Docket 50-305  
Operating License DPR-43  
Response to Request for Additional Information on Fire Protection

RESPONSES TO REQUESTS FOR ADDITIONAL INFORMATION

### ANALYSIS OF CIRCULATING WATER PUMP OIL FIRE

### ANALYSIS OF RELAY ROOM FIRE

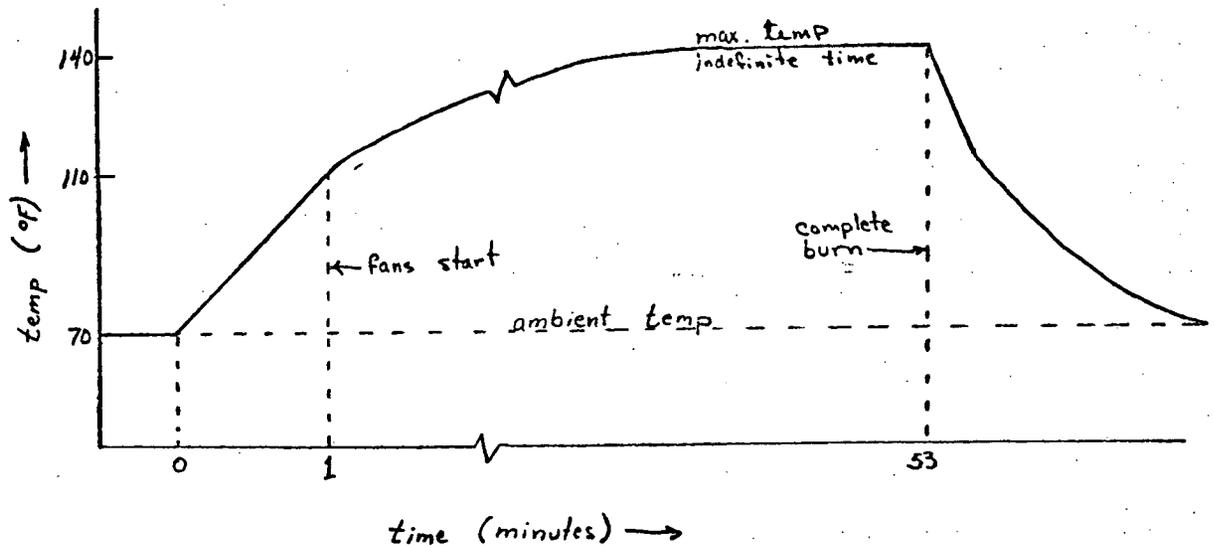
B. As the temperature would rise to the 110°F, the Screenhouse fans would exhaust the atmosphere at a rate of 100,000 scfm. The results of this heat removal and the heat input would yield a temperature rise that would approach some maximum value when the BTUs discharged reached the BTUs input.

The calculation below establishes the air temperature in °F to exhaust the equivalent of the 133,064 BTUs/min input to the air.

1. The equation below establishes the Δ temperature rise above standard ambient temperature, 72°F, that would be equivalent to the same BTU input in the 100,000 scfm removed by the fans.

$$2. \left[ \frac{133,064 \text{ BTU}}{\text{min.}} \right] \cdot \left[ \frac{\text{lb } ^\circ\text{F}}{0.2399 \text{ BTU}} \right] \cdot \left[ \frac{\text{ft}^3}{0.08 \text{ lbs}} \right] \cdot \left[ \frac{\text{min.}}{100,000 \text{ ft}^3} \right] = 69.33 ^\circ\text{F}$$

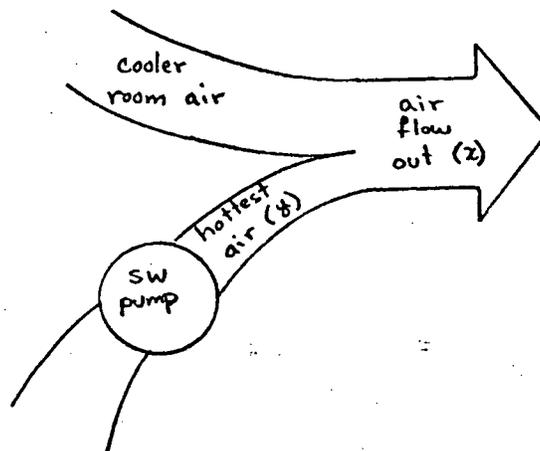
D. The calculation in part C does not account for streaming affects, it assumes uniform heat distribution for the total volume of the Screenhouse. Since no streaming affect can be exactly calculated, the following is an attempt to show the sensitivity of various degrees of streaming.

1. The BTU input remains fixed at 133,064 BTUs/minute. The sensitivity of this calculation will only depend on the quantity and temperature of the air exhausted. The quantity remains fixed at 100,000 scfm but there is a temperature gradient of the air flows to the fan that may result in the Service Water Pump seeing a higher temperature. The graphics below is shown to illustrate this effect.

2. The only parameter that will affect the end result of this discussion is the ratio of the quantity of hot air (y) to total air flow out (x). Since both quantities should have the same relative heat capacity characteristics we could directly equate this ratio to temperature.

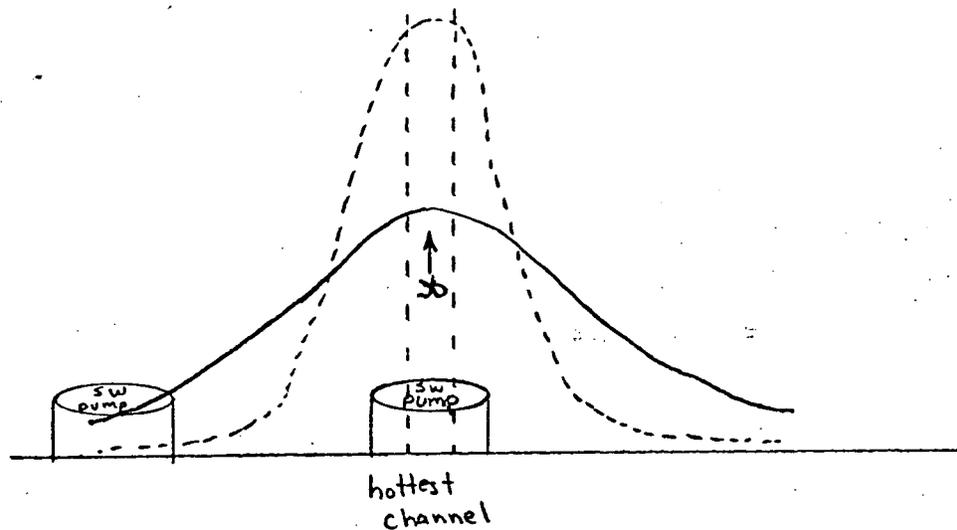
The following illustration shows the gradient affects of the flow path exiting toward the exhaust fans.

7. The result of this analysis shows that you can choose to make the air stream affects as hot as possible to take out one pump, but the higher you raise the factor  $y/x$  the less probable the adjacent pump will be affected.
